TECHNICAL MEMORANDUM

Review of DRAFT: Investigation of Ground Water Contamination near Pavillion Wyoming
Prepared by the Environmental Protection Agency, Ada OK

Prepared by: Tom Myers, Ph.D.
Hydrologic Consultant
Reno NV

Figure 1: Snapshot from EPA (2011) Figure 3 showing frequency of depth for gas wells (top), surface casing for gas wells, and base of domestic wells.

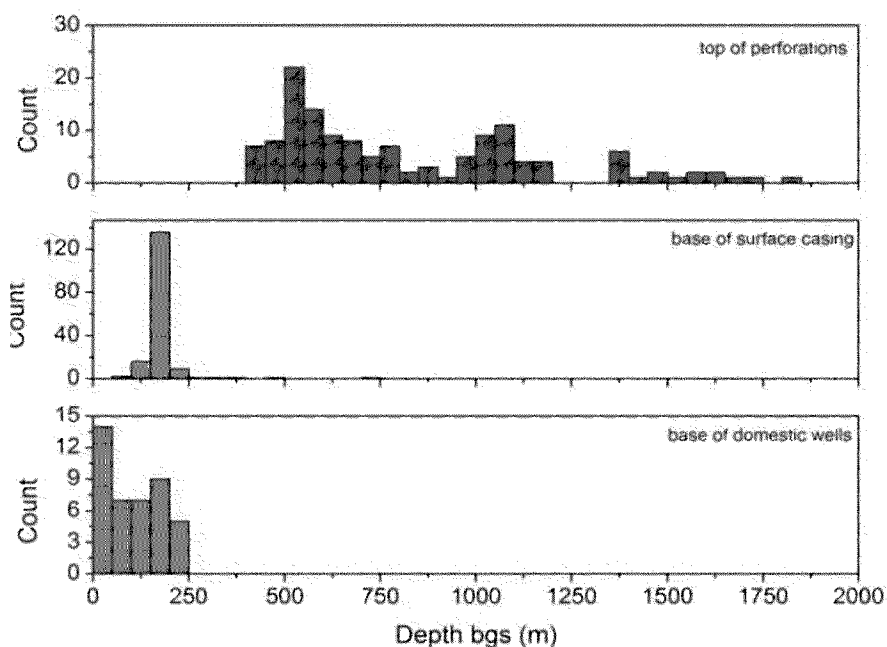
EPA established two dedicated monitoring wells to supplement the data obtained from the water wells. The new monitoring wells were primarily screened below the level of the water wells (Figure 1) and above the gas production wells to “differentiate potential deep (e.g., gas production related) versus shallow (e.g., pits) sources of groundwater contamination” (EPA p 5). The EPA established just two monitoring wells due to a limited budget (Id.). EPA placed the monitoring wells’ screened interval along the conceptualized vertical pathway between the potential contaminant source (i.e. the production wells and/or zone) and the water wells. The monitoring wells were designed appropriately to detect and monitor contaminant movement upward from the production zone to the water wells; if the monitoring wells had been constructed at the same depth as the water wells, they would not have added substantial useful information.

Figure 1 (EPA Figure 3) shows that domestic water wells in the regions are screened at all levels down to about 250 m, or more than 800 feet, with half of the wells being deeper than 300 feet, similar to the depths found by Daddow (1996) in other areas of the aquifer. However, the EPA states the information source was from the State Engineer and homeowner interviews (EPA p 2). It is unclear whether both were used for each well. It is my experience that homeowners have a poor concept of the depth of their well unless they have paperwork that documents it.

Recommendation: The EPA should provide more information about the source of its water well construction data, showing it in EPA Table A1.
